BOSTON SCIENCE CENTER

301 SOUTHAMPTON STREET BOSTON, MASSACHUSETTS

FINAL PROJECT IMPACT
REPORT/(FPIR)

FINAL ENVIRONMENTAL
IMPACT REPORT/(FEIR)

Figure 6 - Proposed Project Site Plan

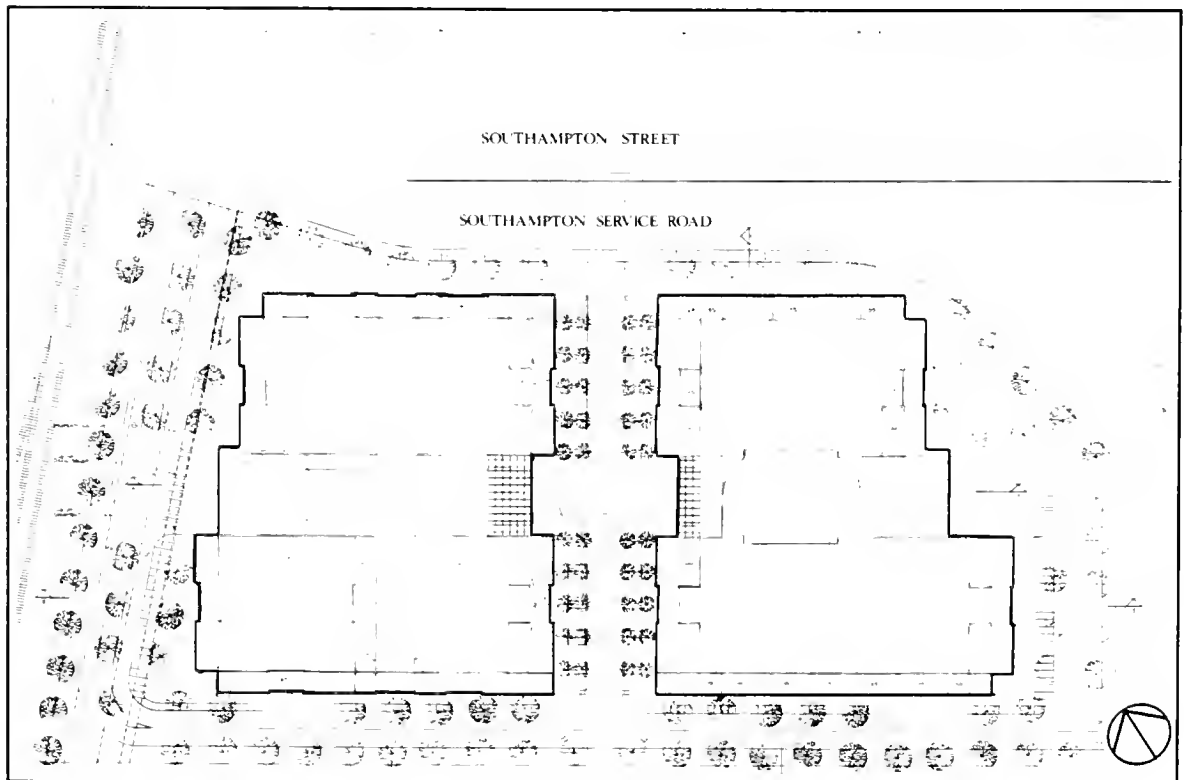
Comment #34:

Provide continuous sidewalks around both buildings.

Sidewalks are being provided around both of the buildings (see Figure 6).

Figure 7 - Parking Plan : Basement Level (P-B)

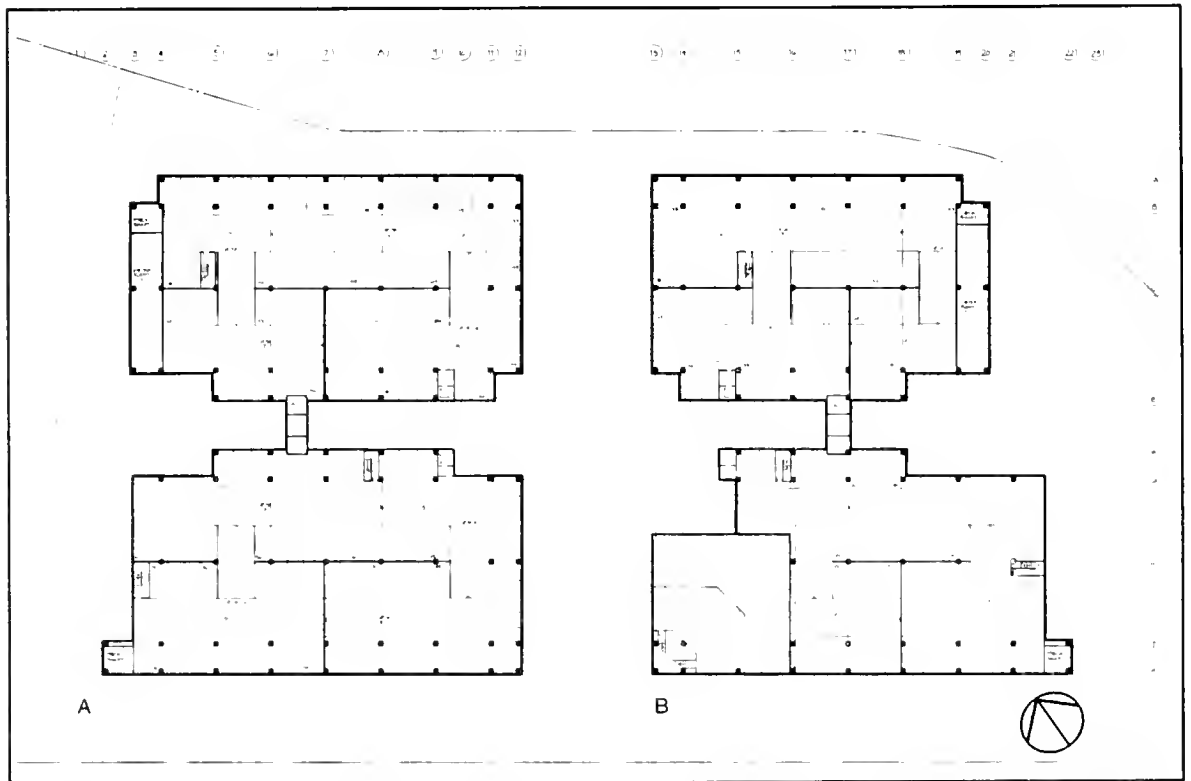
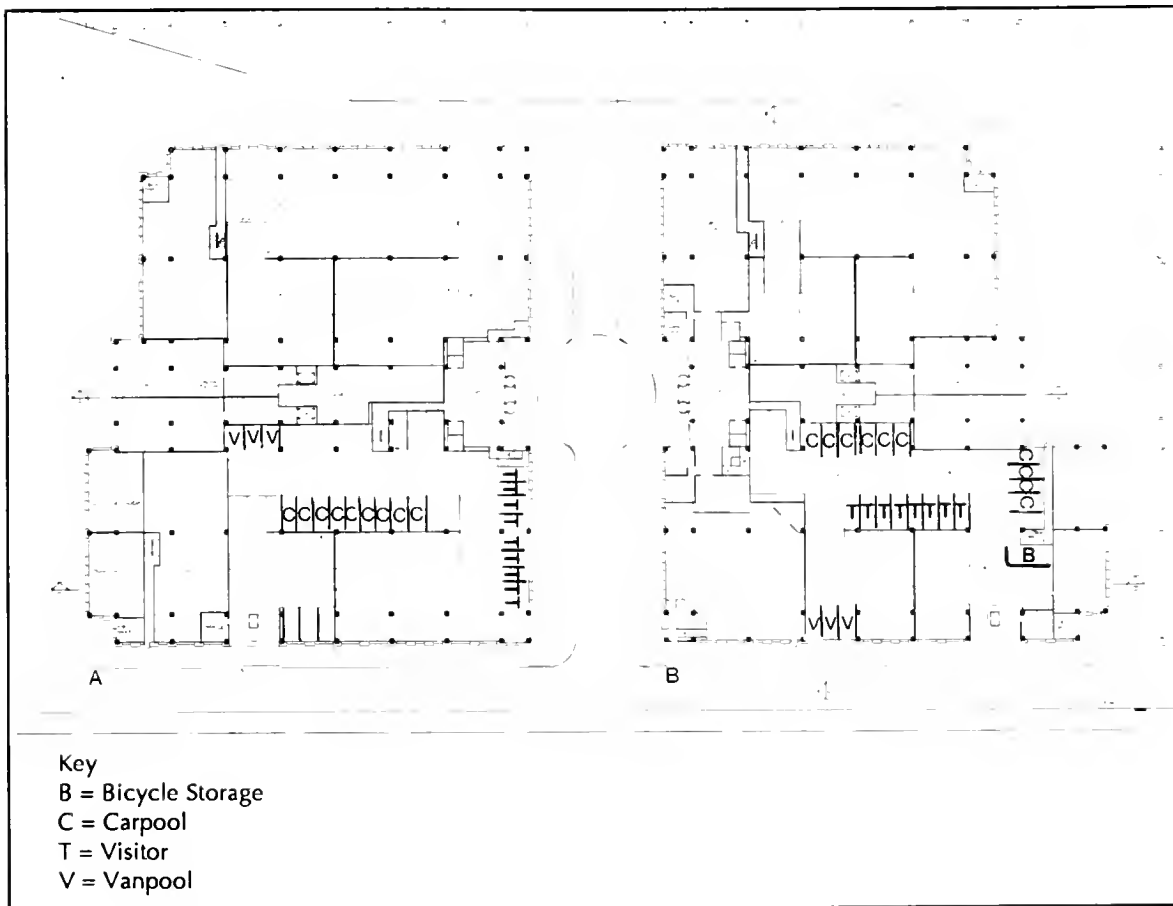
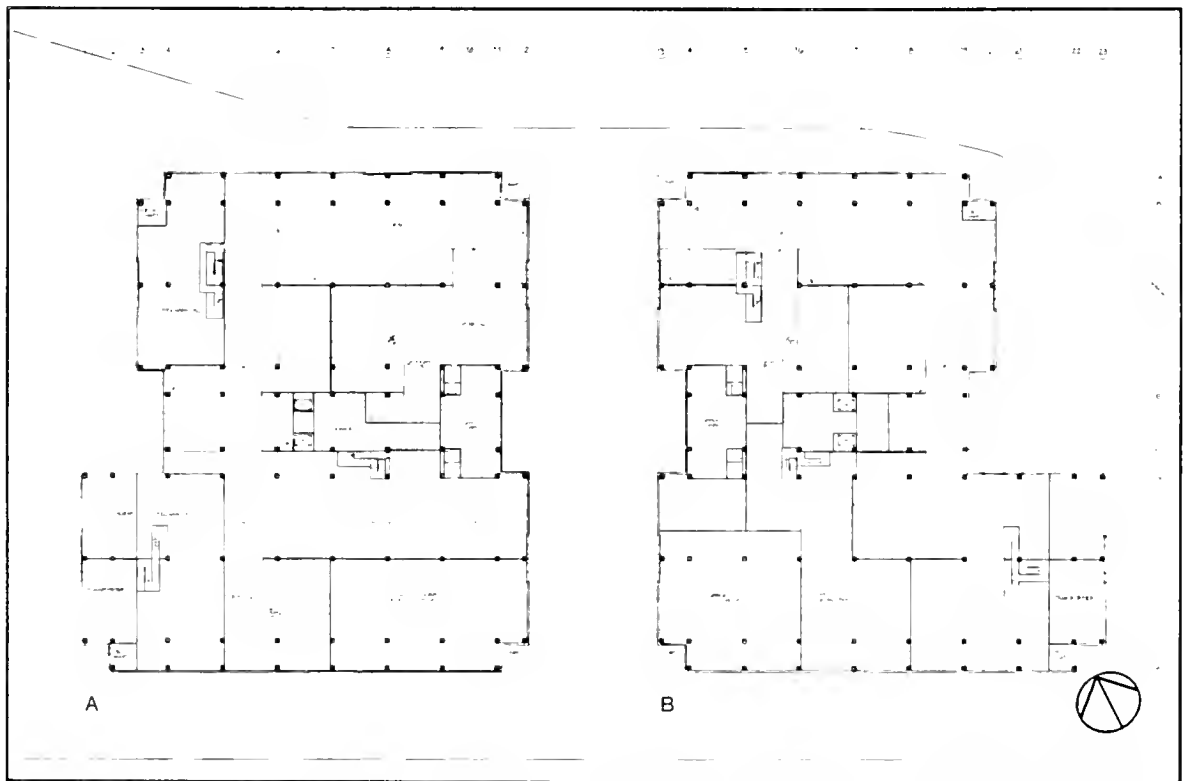
Comment #10:

As shown on the parking plan shown in Figures 7-9, there are 19 spaces for visitors located on Level P-1 and 607 spaces for employees located on the three parking levels, of which 6 spaces are for van pools located on Level P-1; and 20 spaces for carpools located on Level P-1. The shuttle bus will be in continuous service from 7-10 AM and from 3-7 PM. During the midday when the shuttle service is operating on an as-needed basis, no storage will be needed because the bus must remain accessible. Overnight storage of the shuttle bus will be provided in the loading area.
